NOTICE OF DATA INACCURACY

INSPECTION REPORT

Electrical Corporation:	Southern California Edison Company
Report Number:	PAD_SCE_LOK_20251007_1213
Date of Inspection:	October 7, 2025
City and/or County of Inspection:	Three Rivers, Tulare County
Inspector:	Lovepreet Kaur
WMP Year Inspected:	2025
Quarterly Data Report (QDR) Referenced:	Quarter 1 (Q1)
Inspection Selection:	Energy Safety viewed the contents of the Q1 QDR and performed an analysis that resulted in the selection of the WMP initiatives and locations referenced in this report.
Relevant WMP Initiative(s):	8.1.2.1.1 - Covered Conductor
Inspection Purpose:	Assess the accuracy of Southern California Edison Company's QDR data, completeness of its work, and performance of WMP requirements.

Structure ID: 2331133E

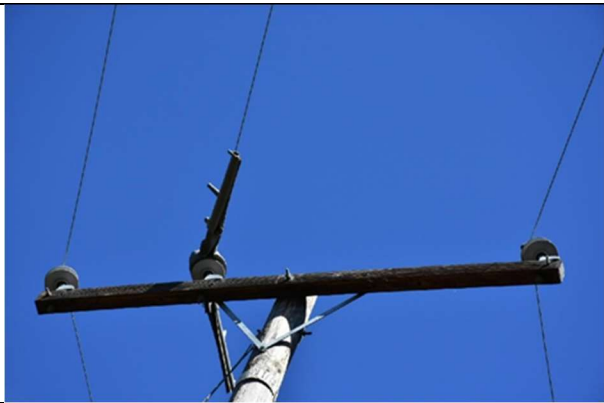
On Pole ID 2331133E, Grid Hardening ID TD2056799-2331133E at 44951-45557 Sierra Dr, Three Rivers, CA, 93271, USA, 36.4750516205668, -118.851794887113, the inspector observed that covered conductor was not installed. The inspector's observations are documented in Data Inaccuracy 1 photographs IA1Img1, IA1Img2, IA1Img3, and IA1Img4, which are attached to this report as Exhibit A.

1. Southern California Edison Company reported in the 2025 Q1 QDR that WMP initiative 8.1.2.1.1 - Covered Conductor installation was completed at the inspection location.
2. Covered conductor was not installed; bare conductor was observed.
